From: Hardy, Alan [Alan.Hardy@ci.tacoma.wa.us]
Sent: Thursday, September 10, 2009 4:58 PM
To: Hunter, Kathy (UTC)
Cc: Matheson, Alan; McCabe, Daniel
Subject: RE: GCPF Application for fencing
Attachments: FreighthouseFencing(Phase1).JPG; FreighthouseFencing(Phase2).JPG

UTC staff is evaluating GCPF projects that were recently submitted. I need additional information on the fencing project under the trestle (between E. L St. and E. G St.) you submitted.

Phase 1

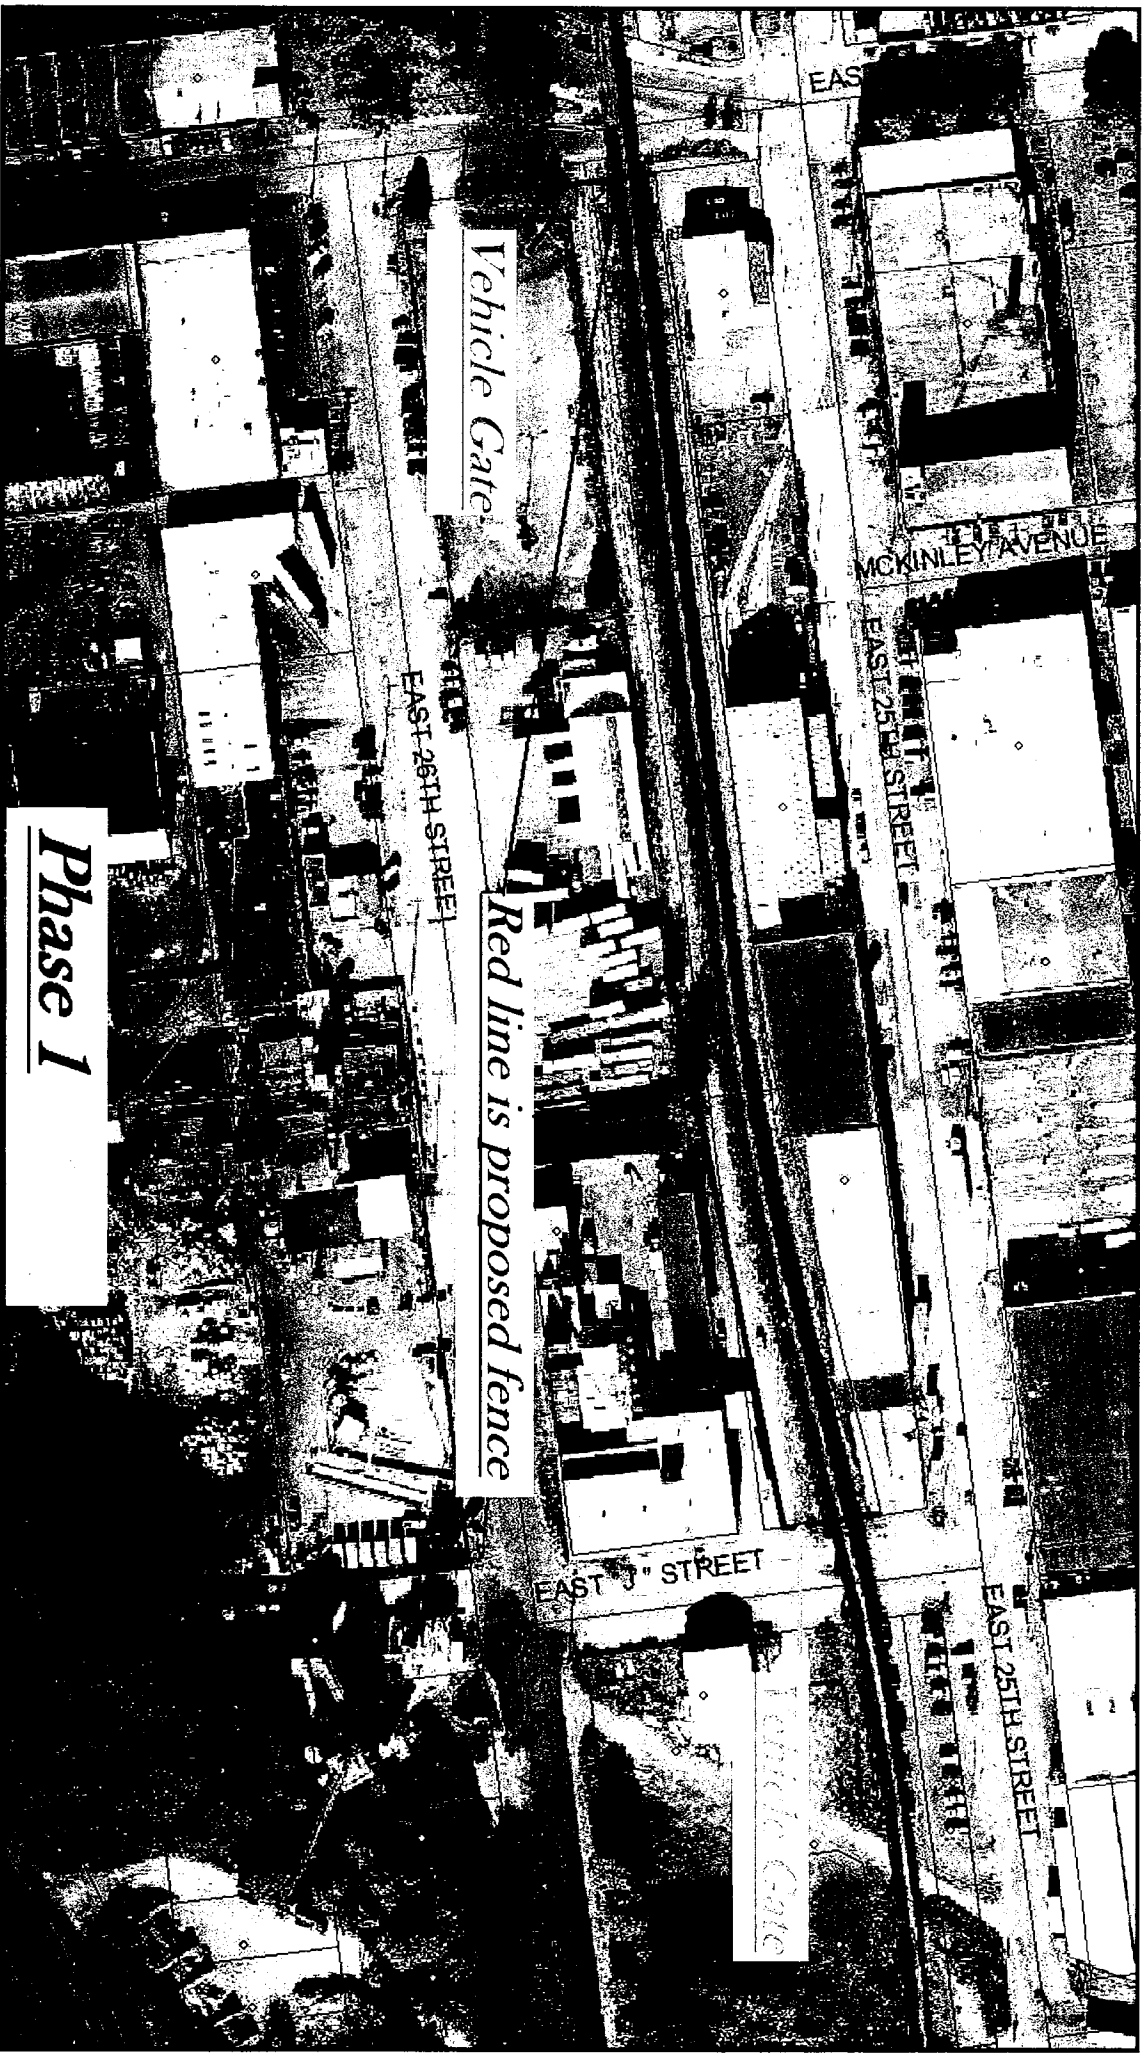
Could you add the following detail to the Phase 1 photo:

- Identify in a different color where the existing fence is located.
- Identify in a different color where Phase 2 fencing will be located.

Q.2. Could you provide additional information about the fencing location that you are proposing in the application. I will refer to this portion of fencing as Phase 1. Will Phase 1 fencing seal a portion of the trestle? How effective will Phase I fencing be deterring trespassing?

Also, I need an estimate of the cost for Phase 1 fencing only. I see the estimate that includes the total proposal but not just Phase 1.

Here are the revised maps. I did a separate one for phase two. Tacoma Rail is prepared to fund the amount of phase 1 over the \$20,000.

The quote we got was for the complete fencing of all segments of the bridge but it was broken down as to gates and per foot of fence. We anticipate that if we can't get additional funding from Sound Transit, which they verbally agreed to, we could effectively seal off the most critical section of the bridge shown in the photo. The approximate footage of the fencing is 600 feet with two vehicle gates and would tie into existing fences surrounding this portion of the trestle. This area is where we had the problem with fires started by transient individuals trying to keep warm in the winter. Using the original quote, we estimated that the amount for this portion, Phase 1, would be approximately \$20,500. I hope this is what you were looking for. If we need to, we can probably get the fence contractor to give us a revised quote on the reduced portion of fencing if you think this is necessary.
